SUBJECT: BROWNS FERRY NUCLEAR PLANT, UNITS 1,2 AND 3 - STAFF ASSESSMENT OF INFORMATION PROVIDED PURSUANT TO TITLE 10 OF THE *CODE OF FEDERAL REGULATIONS* PART 50, SECTION 50.54(f), SEISMIC HAZARD REEVALUATIONS FOR RECOMMENDATION 2.1 OF THE NEAR-TERM TASK FORCE REVIEW OF INSIGHTS FROM THE FUKUSHIMA DAI-ICHI ACCIDENT (TAC NOS. MF3764, MF3765 AND MF3766)

STAFF ASSESSMENT BY THE OFFICE OF NUCLEAR REACTOR REGULATION

RELATED TO SEISMIC HAZARD AND SCREENING REPORT

BROWNS FERRY NUCLEAR PLANT, UNITS. 1, 2, AND 3

Figure 3.3-1 Plot of Staff's and Licensee's Base Case Shear-Wave Velocity Profiles for the BFNP site

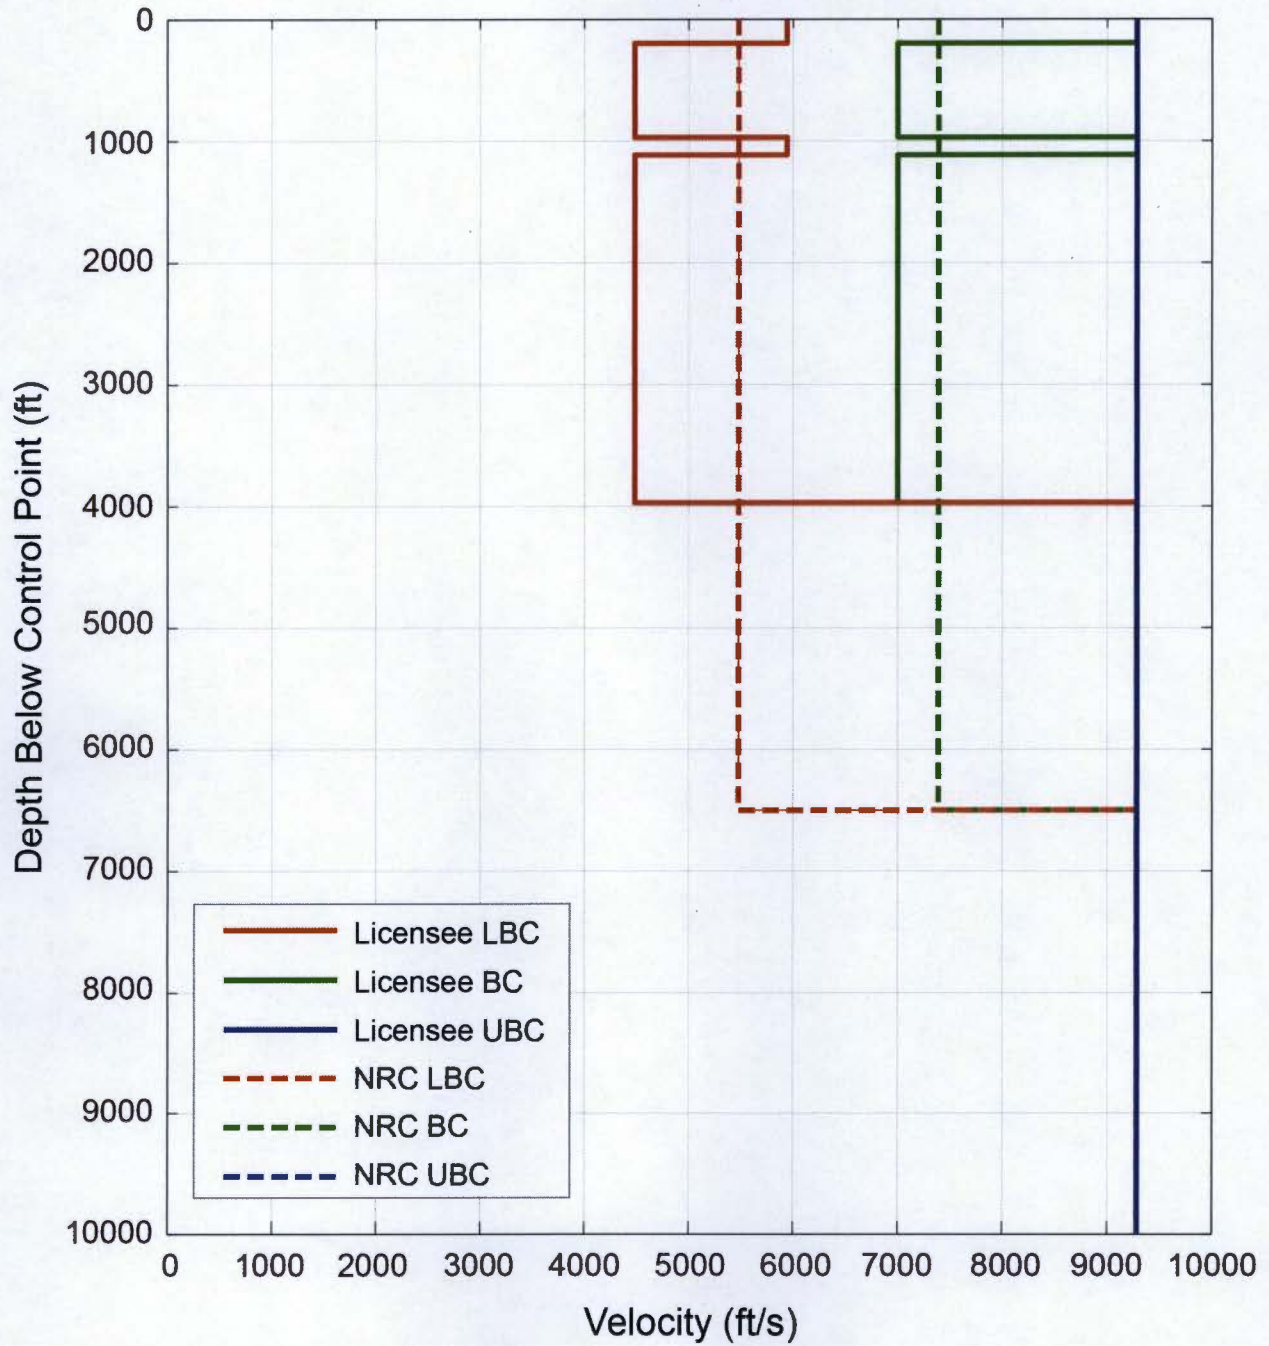
The NRC staff developed three velocity profiles based on the geological information in UFSAR (TVA, Amendment 25.3). Core information from 29 holes drilled in the main plant area places the bedrock at about 50 ft [15 m] below the ground surface. The bedrock below the control point is limestone of Mississippian age Fort Payne Formation. The staff used laboratory measurements of limestone shear-wave velocity reported in Mavko et al. (2009) as well as the velocity profiles in EPRI (2008) to develop its three base case profiles. The measured shear wave velocity for limestone (Mavko et al., 2009) ranges between 5,479 ft/s [1,670 m/s] and 9,974 ft/s [3,040 m/s]. Assuming that this range represents 10 percent and 90 percent fractiles in a log-normal distribution, NRC staff estimated the median shear wave velocity of 7,392 ft/s [2,253 m/s] for the best estimate profile. To develop the upper and lower profiles, the staff assumed a standard deviation of 0.23, which is consistent with the guidance in the SPID. The NRC staff placed the reference or base rock boundary at a depth of 6,562 ft [2,000 m] below the control point (EPRI, 2008). Figure 3.3-1 of this assessment shows a comparison between the staff's and the licensee's base case profiles. The staff's best estimate base-case profile is similar to that of the licensee; however, the licensee's upper and lower profiles are wider, which reflects the licensee's use of a higher standard deviation (0.35) than that used by the staff (0.23).

Figure 3.3- 1 Plot Comparing the Staff's and the License's Median Amplification Functions and Uncertainties for the BFNP site

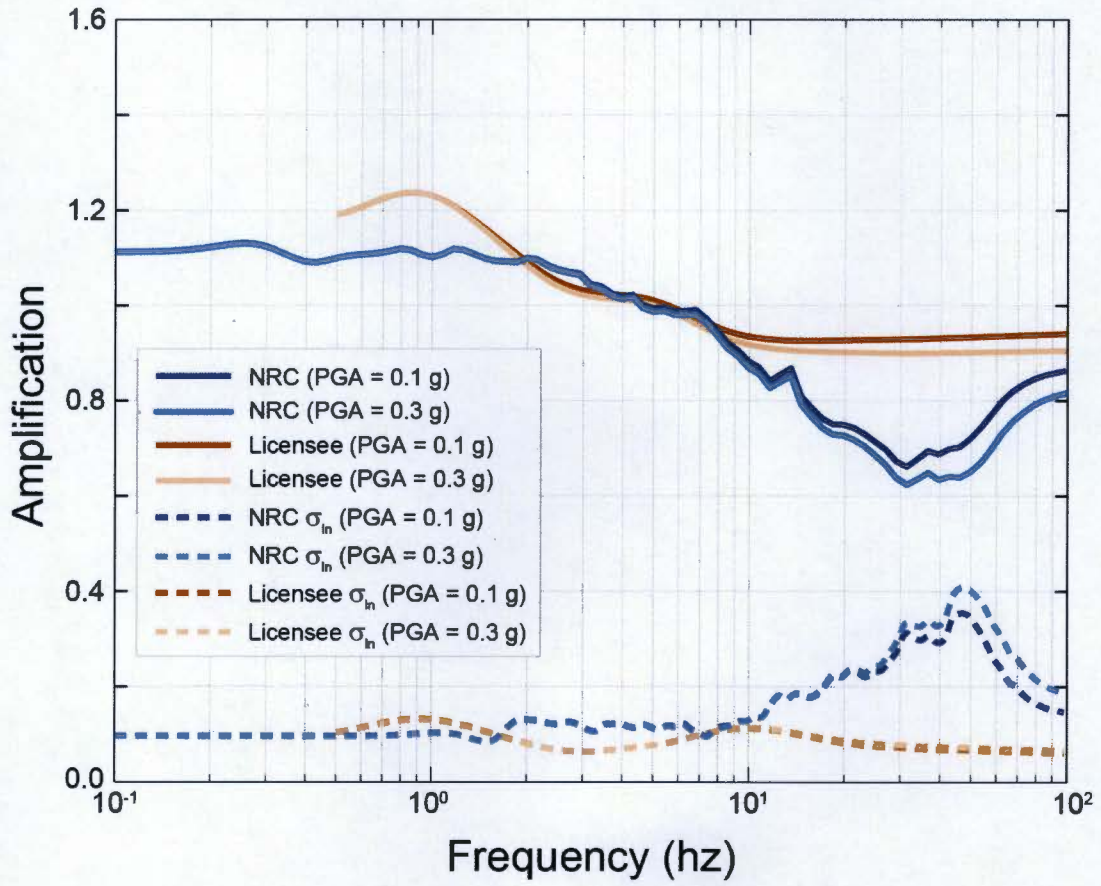
Figure 3.3-2 of this assessment shows a comparison of the staff and the licensee median site amplification functions and uncertainties for two of the eleven input loading levels. As shown in this figure, the licensee's amplification functions are slightly higher at frequencies below 2 Hz, and above 8 Hz. The standard deviations of the licensee are almost identical to those of NRC below 10 Hz, but lower at frequencies above 10 Hz. The differences in the amplification functions are mainly due to differences in the velocity profiles of the staff and the licensee; however, these small differences are within the limits of the uncertainty, and judged by staff to be reasonable.

Figure 3.3-2 Plot Comparing the Staff's and the Licensee's Mean Control Point Hazard Curves at a Variety of Frequencies for the BFNP site

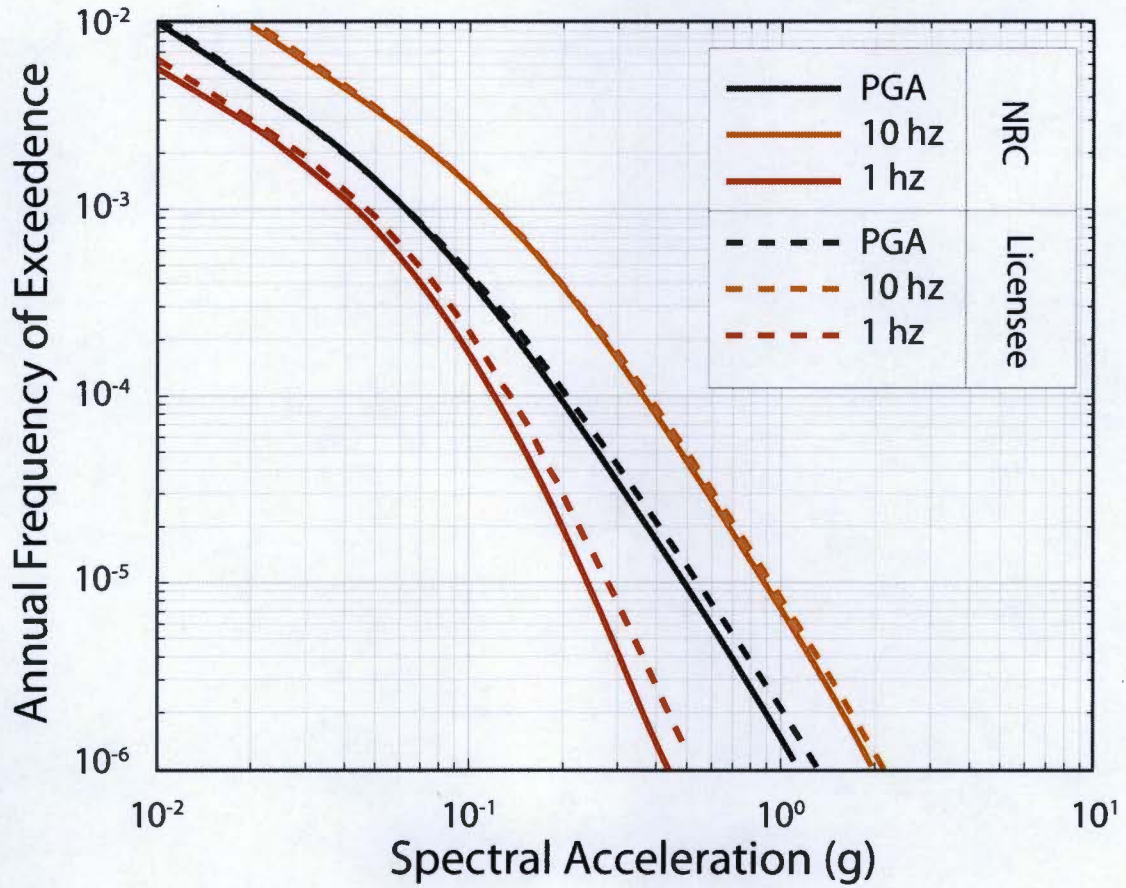
Overall, the licensee's approach to modeling the subsurface rock properties and their uncertainty, results in similar site amplification factors. As shown in Figure 3.3-3 of this assessment, the control point hazard curves developed by the licensee and the staff are also very similar. Appendix B of the SPID provides guidance for performing site response analyses, including capturing the uncertainty for sites with less subsurface data; however, the guidance is neither entirely prescriptive nor comprehensive. As such, various approaches in performing site response analyses, including the modeling of uncertainty, are acceptable for this application. In summary, the staff concludes that the licensee's site response was conducted using present-day guidance and methodology, including the NRC-endorsed SPID. The staff performed independent calculations to confirm that the licensee's amplification factors and control point hazard curves adequately characterize the site response, including the uncertainty associated with the subsurface material properties, for the BFNP site.

Figure 3.4-1 Comparison of the Staff's GMRS, Licensee's GMRS, and the SSE for the BFNP site

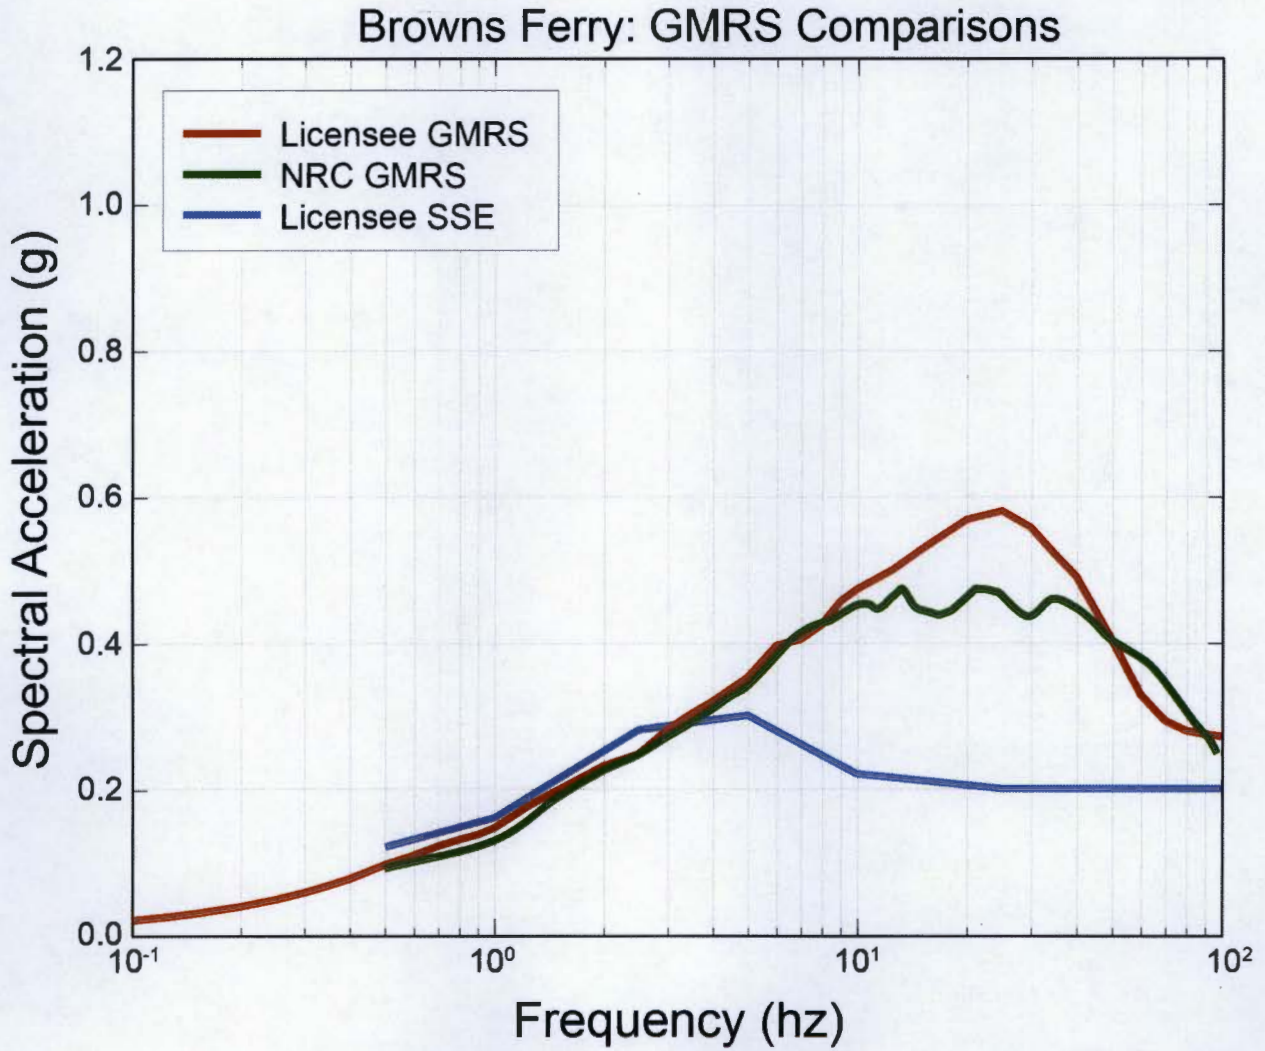
The staff independently calculated the 10^{-4} and 10^{-5} UHRS using the results of its confirmatory PSHA and site response analyses, as described in Sections 3.2 and 3.3 of this staff assessment, respectively. Figure 3.4-1 of this assessment shows a comparison of the GMRS determined by the licensee to that determined by the staff.

As shown in Figure 3.4-1, the licensee's GMRS shape is generally similar to that calculated by the staff at frequencies less than 10 Hz. However, NRC staff's confirmatory GMRS is somewhat lower than the licensee's at frequencies above 10 Hz. As described in Section 3.3 of this assessment, the staff concludes that these minor differences over the higher frequency range are primarily due to the differences in velocity profiles as part of the site response analyses performed by the licensee and staff. The staff concludes that these minor differences are acceptable for this application because the licensee followed the guidance provided in the SPID with respect to both the PSHA and site response analysis for the BFNP site.

The staff confirms that the licensee used the present-day guidance and methodology outlined in RG 1.208 and the SPID to calculate the horizontal GMRS, as requested in the 50.54(f) letter. The staff performed both a PSHA and site response confirmatory analysis and achieved results consistent with the licensee's horizontal GMRS. As such, the staff concludes that the GMRS determined by the licensee adequately characterizes the reevaluated hazard for the BFNP site. Therefore, this GMRS is suitable for use in subsequent evaluations and confirmations, as needed, for the response to the 50.54(f) letter.
